| - | 17.5x6.00 | DRAWING NO |
| | | 600132 |

AA-SECTION

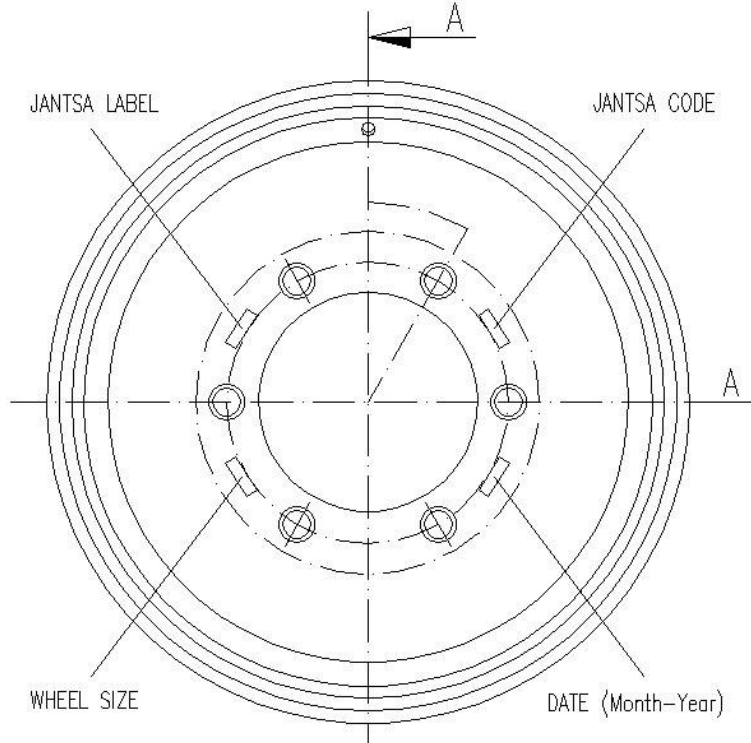
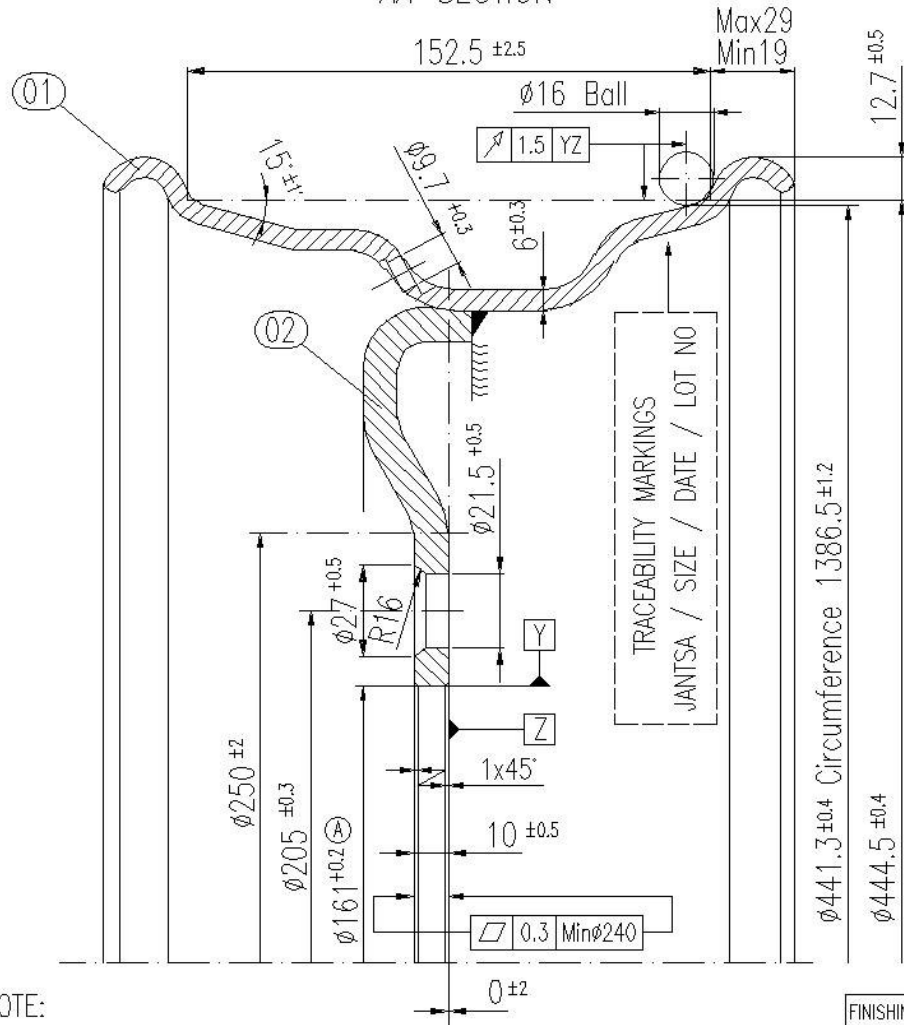
| LETTER | DESCRIPTION | REVISION | DATE | REV.NO |
|--------|---|---------------------|----------|--------|
| Ⓐ | Bore hole diameter tolerance is changed. Before +1 Now +0.2 | Drawing is changed. | 22.12.04 | 1 |
